After Mike's visit

TB33w3b(h) DRAFT 10/4/19 3.3 dbFh362b

TB30c(h) 3.3 dbFh362c

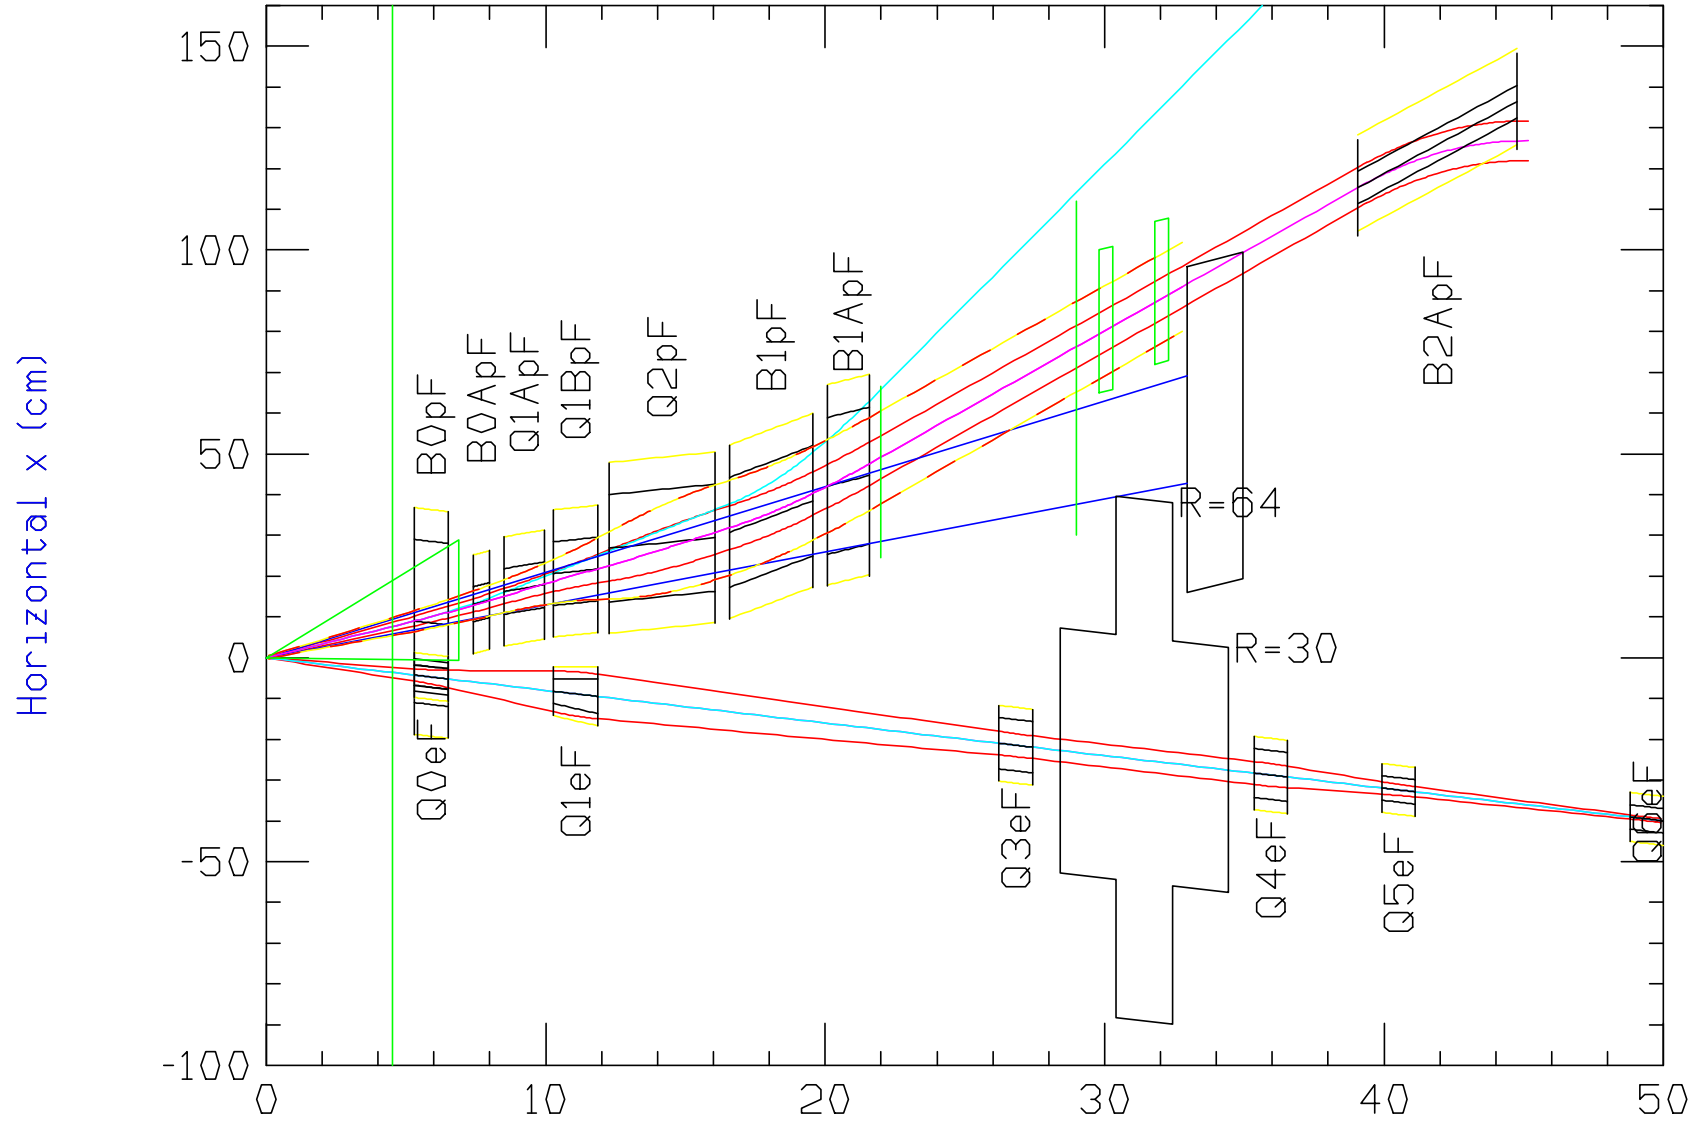
Suggestion 1 Layout Modify eF lattice, leave ZDC

Suggestion 2 Modify eF lattice, move ZDC
